**RE: Anasazi Ridge, Unit 3
Drainage Report, and Grading and Drainage Plan
Engineer's Stamp Date 10-24-2014 (File: A10D002G)**

DRAINAGE REPORT

ANASAZI RIDGE UNIT 3 SUBDIVISION

RE: **Anasazi Ridge, Unit 3**
Drainage Report, and Grading and Drainage Plan
Engineer's Stamp Date 6-19-2014 (File: A10D002G)

CITY PROJECT NO. **XXXXXX** ZONE MAP NO. **A-10-Z** SHEET **1** OF **2**

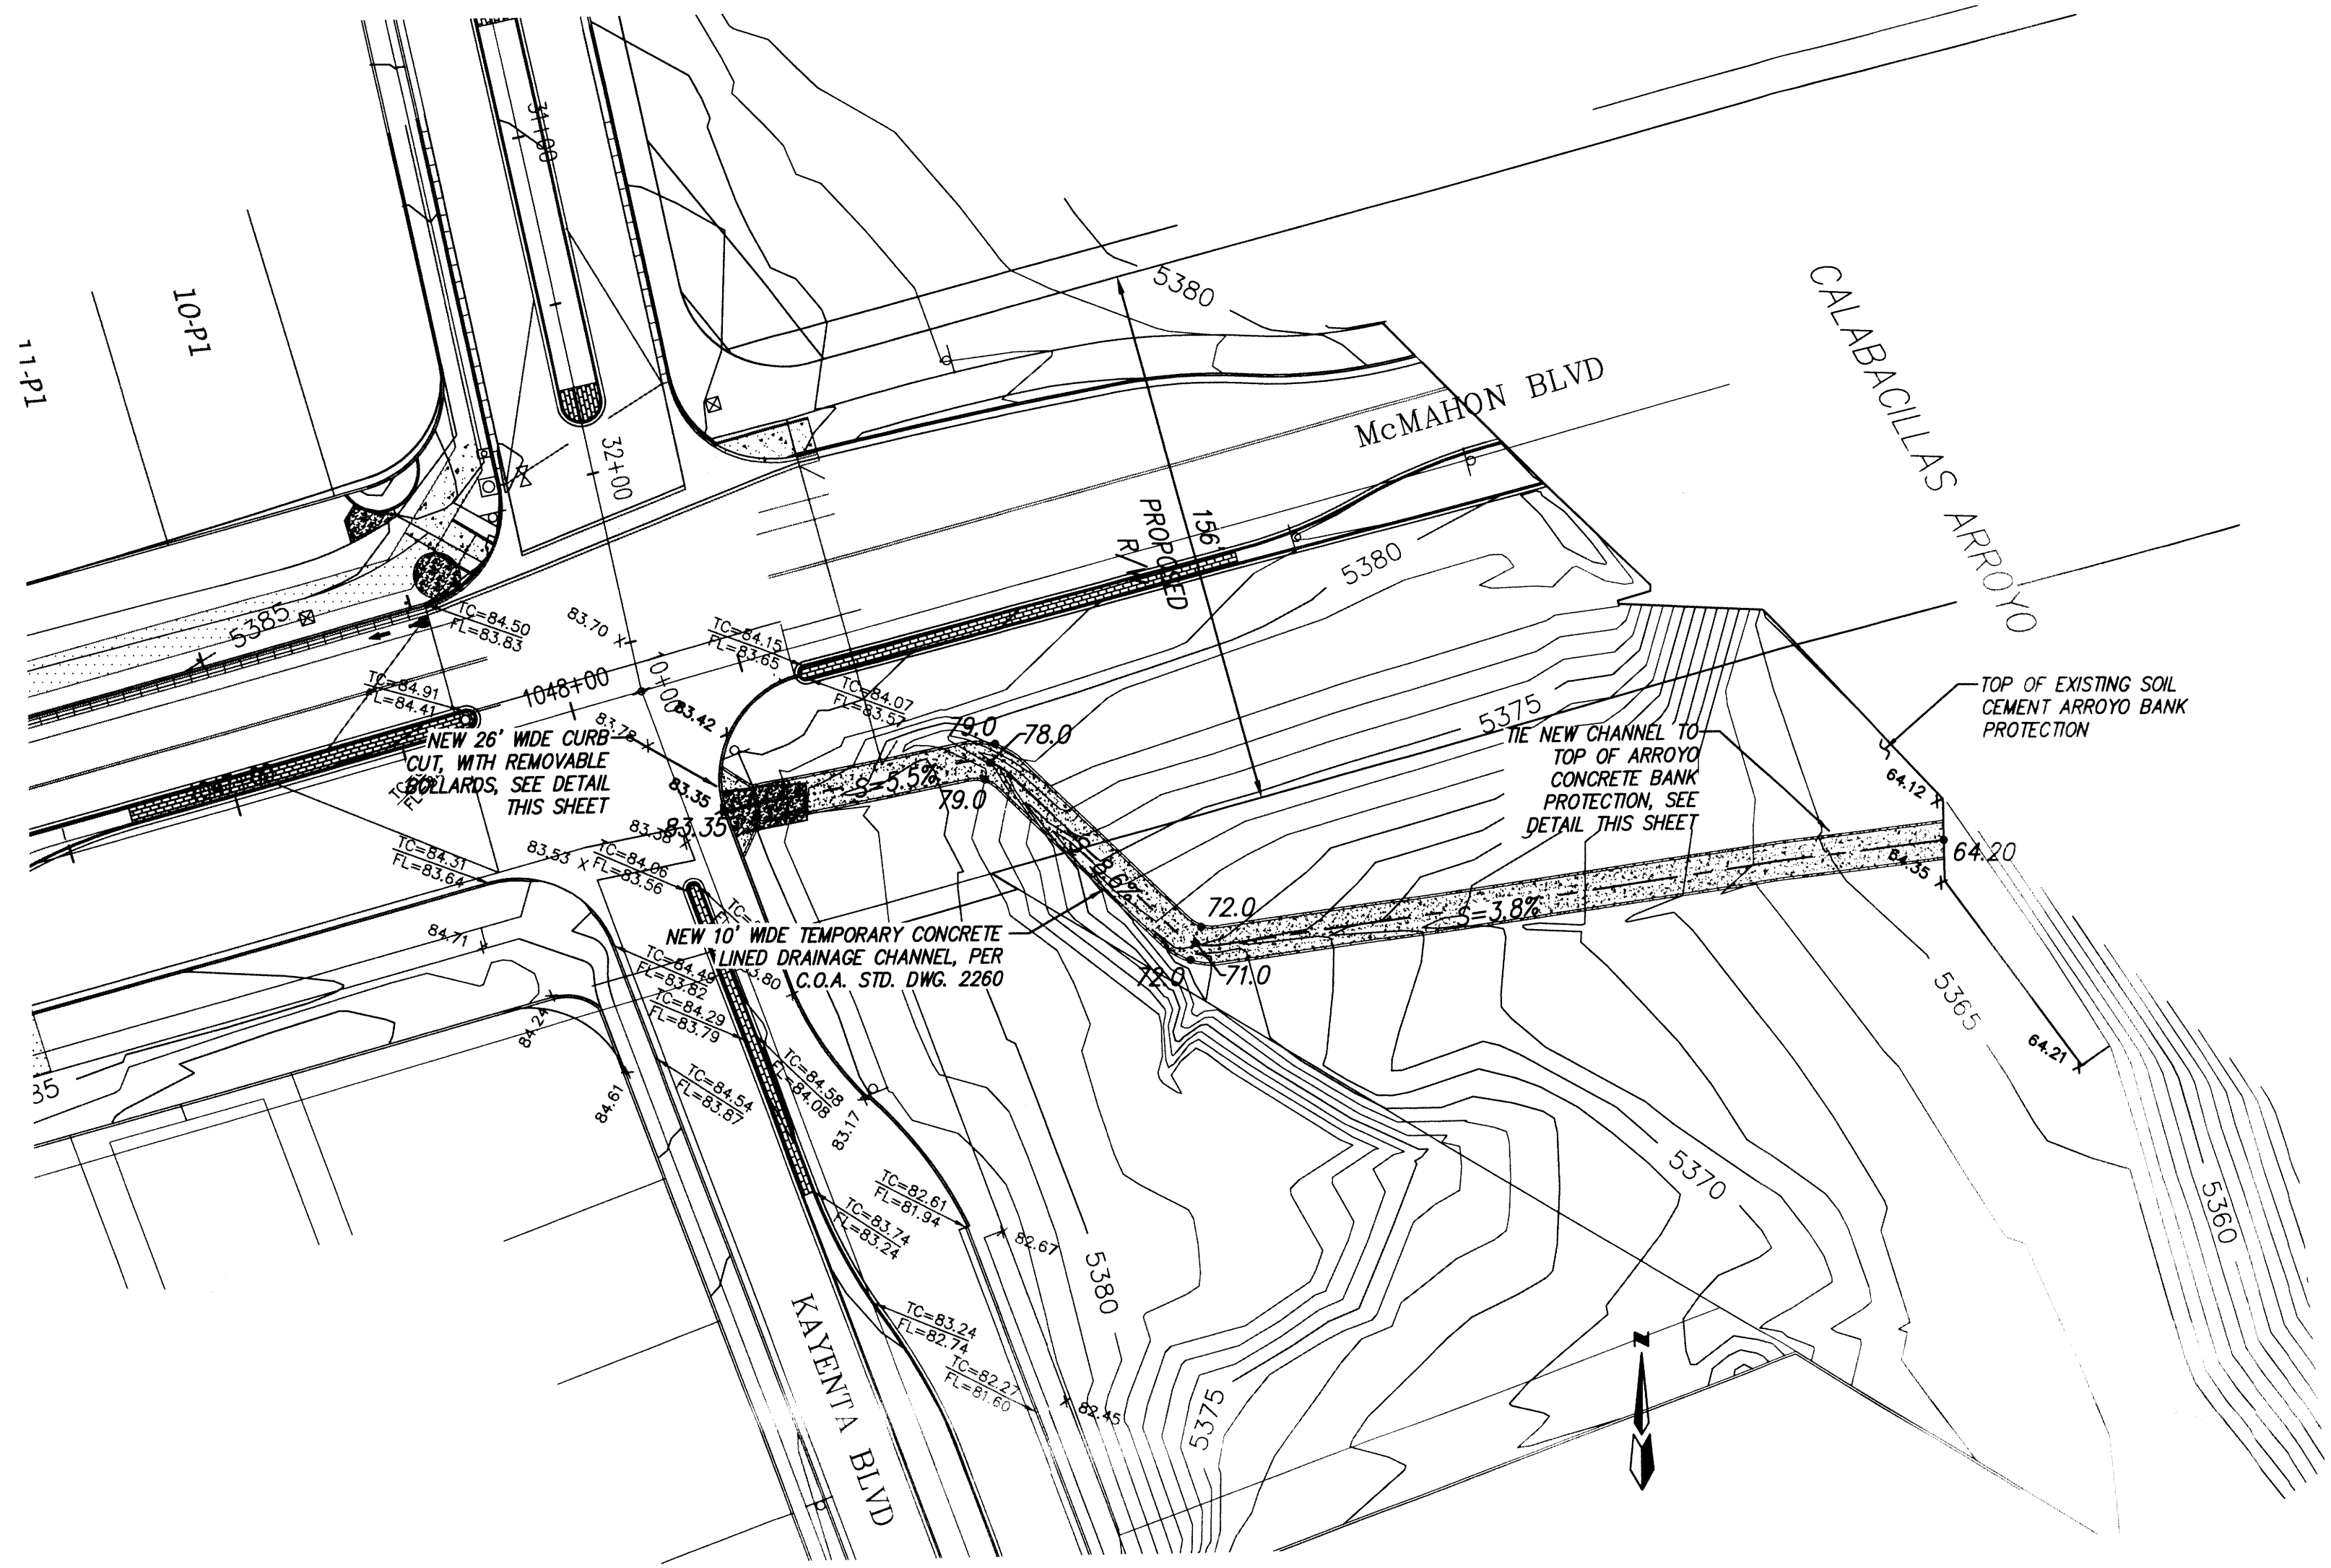
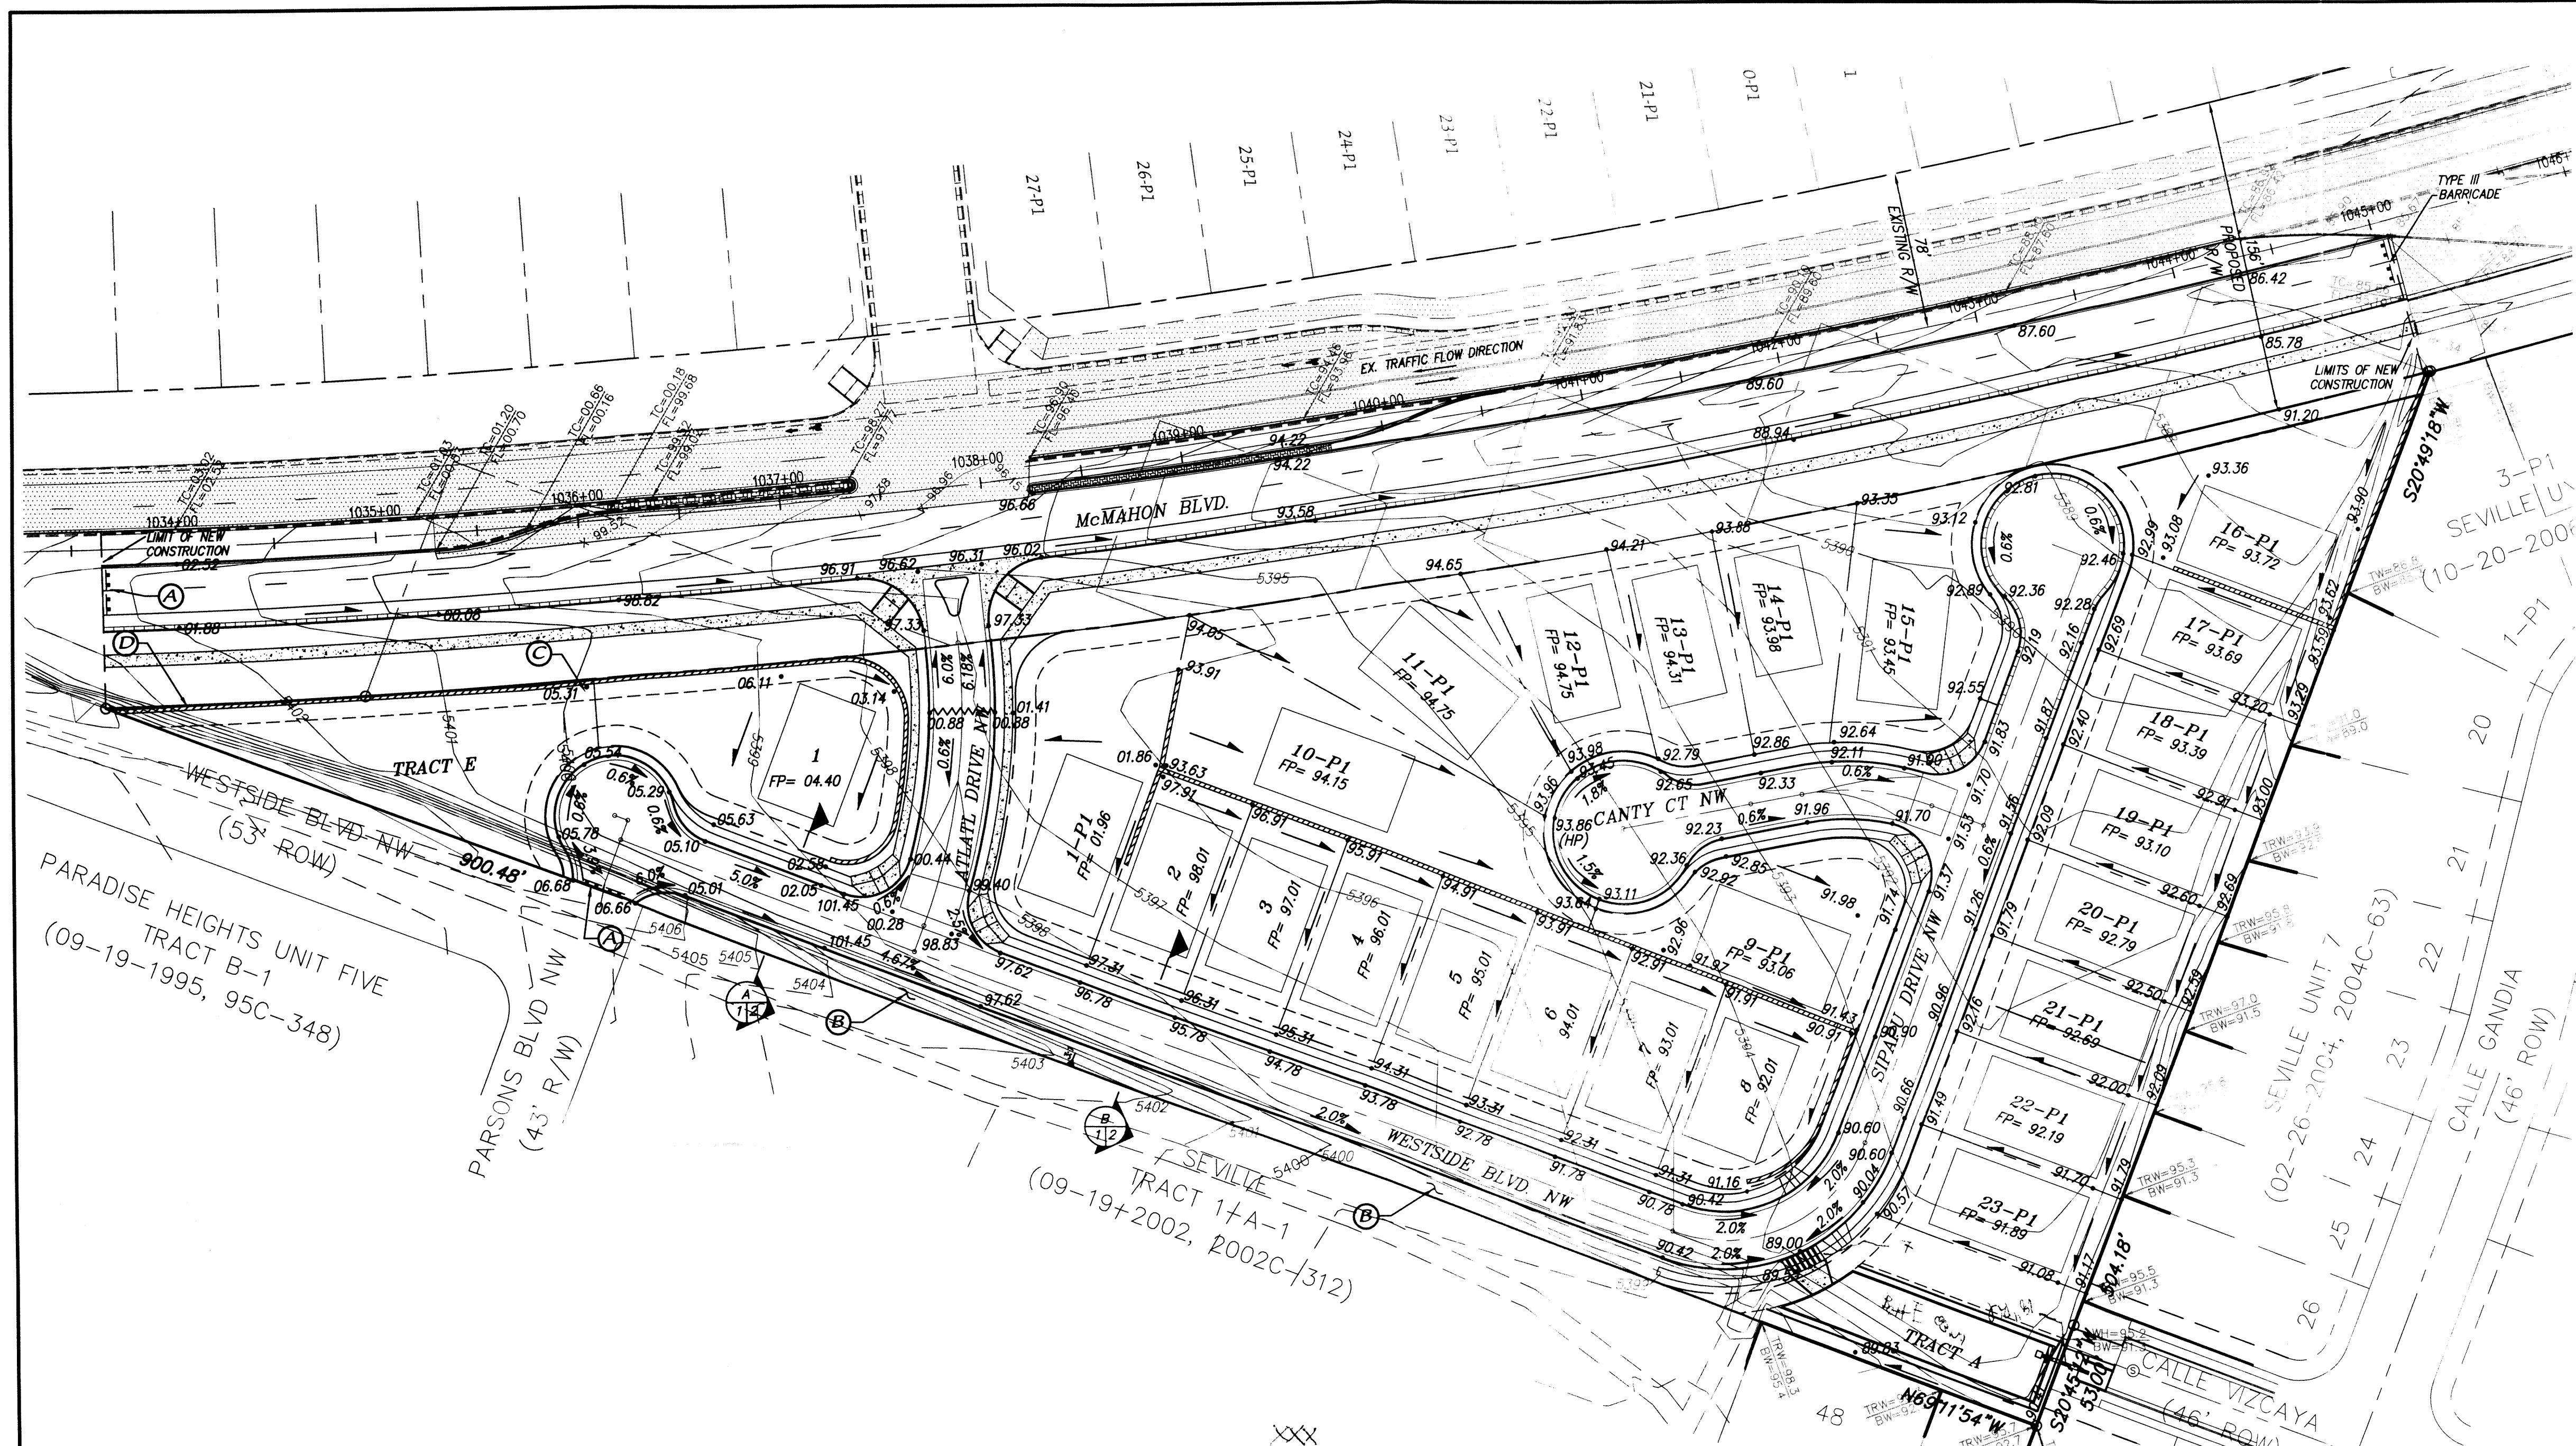
3. Page 3 in the report is duplicated, the first seems to be obsolete.
4. Show proposed contours in Tract E, additional spot elevations in Lot 1, and TW/BW elevations of wall bounding both.

5. Show the Benchmark and Datum information. Verify the existing contours are in the '88 datum.
6. In order that future development to southwest, in Seville Tract 1-A-1, does not discharge into this subdivision via Parsons Blvd., show a waterblock, High Point, or extended proposed grades where Parsons connects to Westside Blvd.

7. Discharge to Calle Vizcaya should utilize the existing concrete rundown, and the discharge details should be shown on the plan.
8. Sidewalk culverts at Sipapu/Westside Blvd should be replaced with an inlet and storm drain to the detention pond.

9. Due to the depth, the detention pond appears to need a fence/railing around it. The pond should be called out on the plan and details shown on the plan.

CALABACILLAS ARROYO CHANNEL OUTFALL

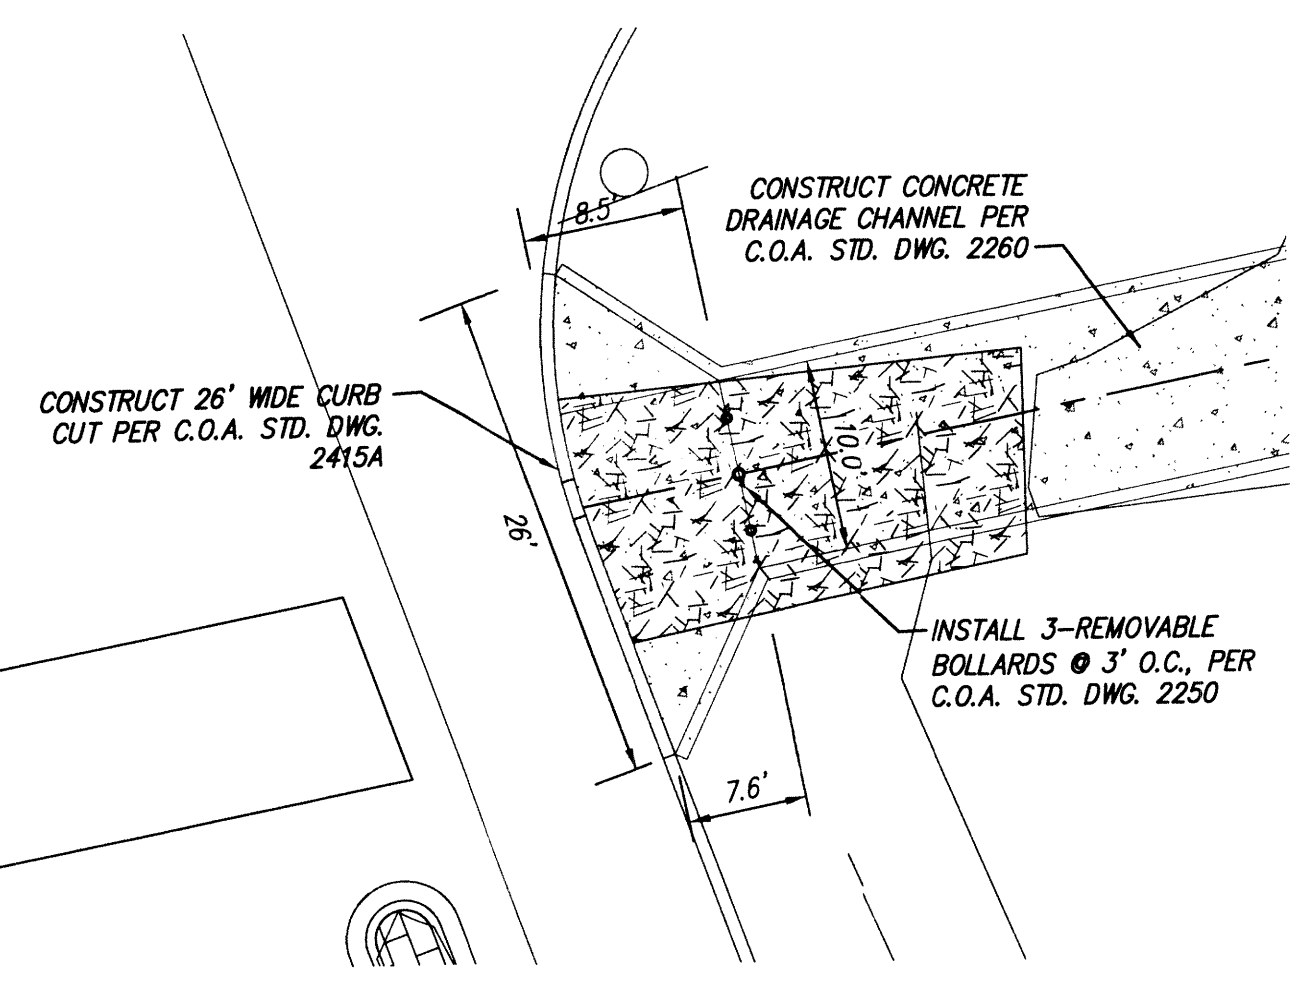
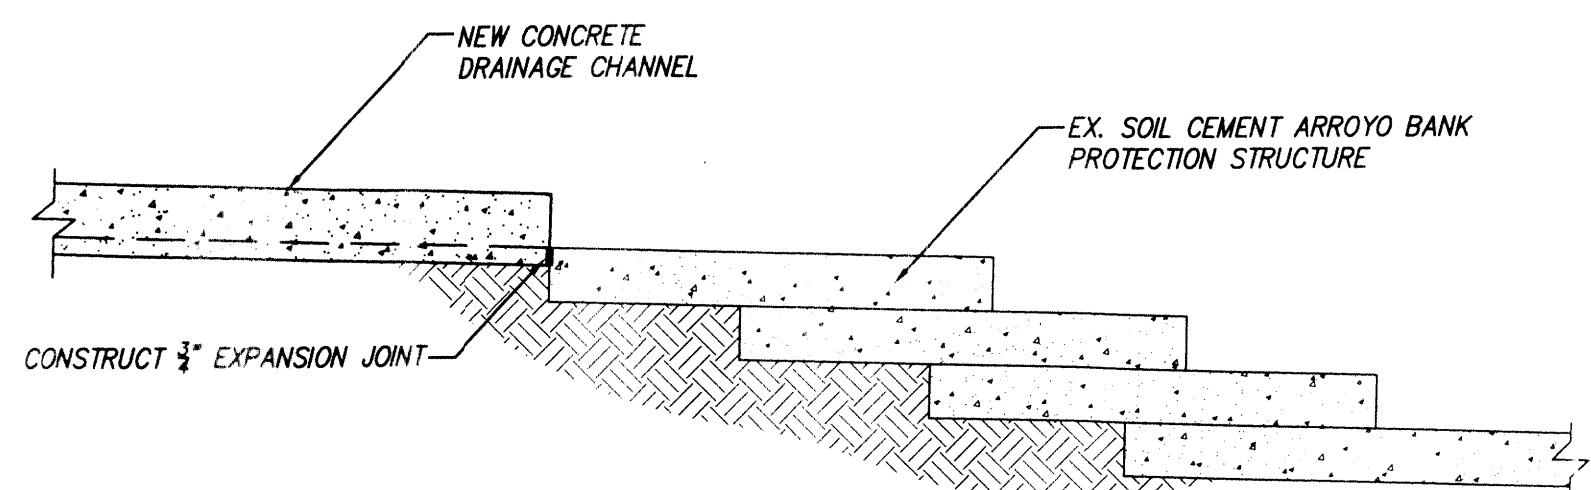
- b. The 10ft wide channel rundown cannot be added to the infrastructure list since the M.O.A. between AMAFCA and the City was never completed.
2. AMAFCA comments for DRB for July 16, 2014 requested that the 100-yr flow rate be shown on the plan for the concrete channel.
